# DELEGATE REPORT MINISTERIAL PLANNING REFERRAL

City of Melbourne file reference: TPM-2019-4/A

**DELWP Application No.** PA1800480-2

Address: 102-108 Jeffcott Street, West Melbourne (Stage 1)

Excerpt from 'Overall Plan – Ground' Drawing No.TP1.104 (Revision 2), the decision plans accompanying management's recommendation to FMC1 September 2019

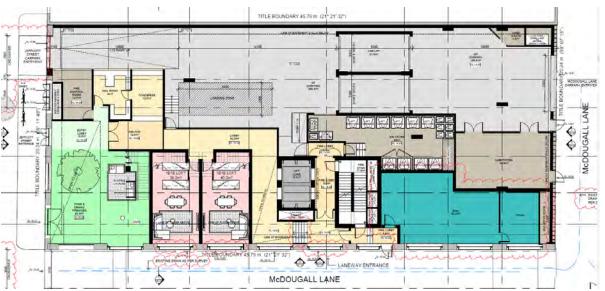
Significant changes to the ground plane of the tower above 102-108 Jeffcott Street, West Melbourne, including the provision of an additional access to Jeffcott Street, resulted in the removal of three fine-grain retail tenancies that made a strong contribution to the building's activation with Jeffcott Street and McDougall Lane.

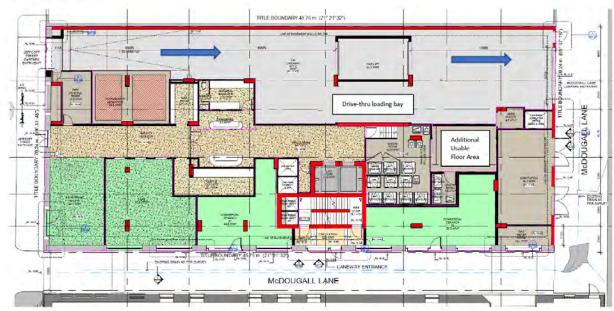
- Swept-path diagrams for the basement parking spaces showed that some parking spaces
  would require multiple vehicle manoeuvres to access (and would be unusable). It was
  suggested that these spaces be removed.

- The proposed single-width crossover arrangement to Jeffcott Street was found to be
  unacceptable, as it would have resulted in entering vehicles having to reverse onto the footpath
  / road in the event that another car was existing, causing safety concerns. Council's Traffic
  Engineer recommended a double-width crossover be provided to enable vehicles to
  concurrently enter and exit the site.

Consultation was undertaken between the project Traffic Engineer and Council's Traffic Engineer to resolve this concern, noting that provision of a double-width crossover would have resulted in the removal of additional (substantial) heritage fabric to the Jeffcott Street façade and contributed to the further erosion of the ground floor's capacity to deliver active uses and commercial floor area.

On 1 March 2022, the permit applicant supplied an updated plan detailing alternative for the development, which would result in the following vehicle movements through the site:

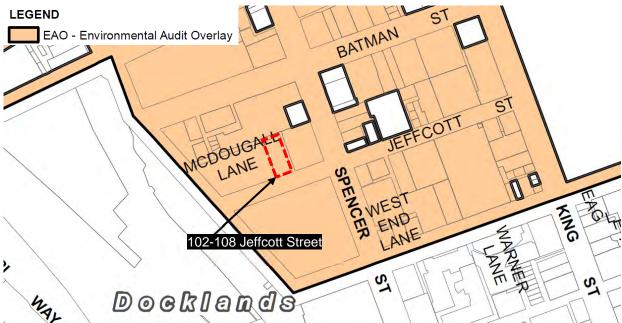
Require provision of end of trip facilities in the basement of the development complying with the
requirements of Clause 52.34 by replacing existing car parking spaces, and require the deletion
of any car parking spaces that would be rendered unusable by virtue of an excessive number of
vehicle movements being required for cars to access spaces.

The above requirement will contribute to the further reduction of the number of car parking spaces within the development (currently 50), bringing the car parking provision closer to the maximum number entertained for the site by proposed PO14 in PSA C385melb (38).

Give force and effect to the proposed access plan supplied by the permit applicant on 1 March 2022 to address Council's Traffic Engineer concerns relating to the single-width vehicle crossing to Jeffcott Street.
